Access Compliance Report Public Rights-of-Way (Curb Ramps)

Main Street: CHRISTY_LN Cross Street: BLUME_DR Location: SW

ADA ID: RPRK211216122429 Ramp Type: Type 1 - Perpendicular Diagonal Initial Pass/Fail: Pass Overall Compliance: No Severity Score: 15

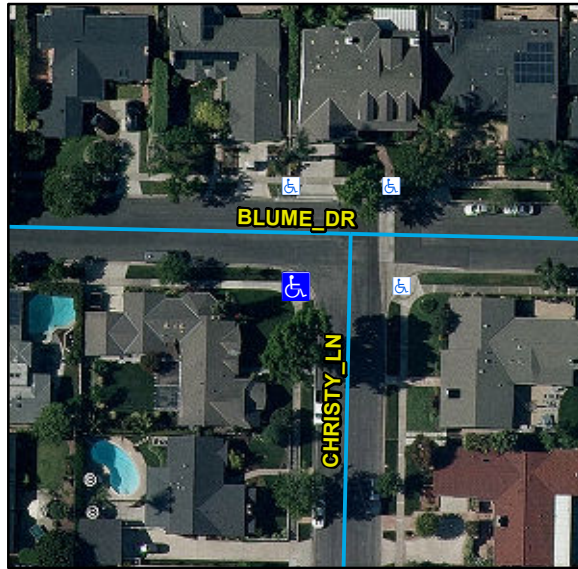
Crossing 1 Slope (%)	5.6		Crossing 2 Slope (%)	5.1
	Crossing 1 Cross Slope (%)	1.9		Crossing 2 Cross Slope (%)	0.5
Yes	Gutter Ponding	No	Yes	Curb Slope	1.2
Yes	Gutter Lip Height (in)	0		Road Run Slope (%)	4
No	Gutter Run Slope (%)	6.4		Road Cross Slope (%)	6.2
Yes	Gutter Cross Slope (%)	1.2			
Yes	Overall Surface Condition: Acceptable		No	Perp Joint Present	No
	Cross Gutter Present?	No		Spandrel Present?	No
	Replace Cross Gutter?	N/A		Replace Spandrel?	N/A

Remove & Replace Curb Ramp With Two New Directional Ramps or Equivalent. Remove & Replace Gutter.
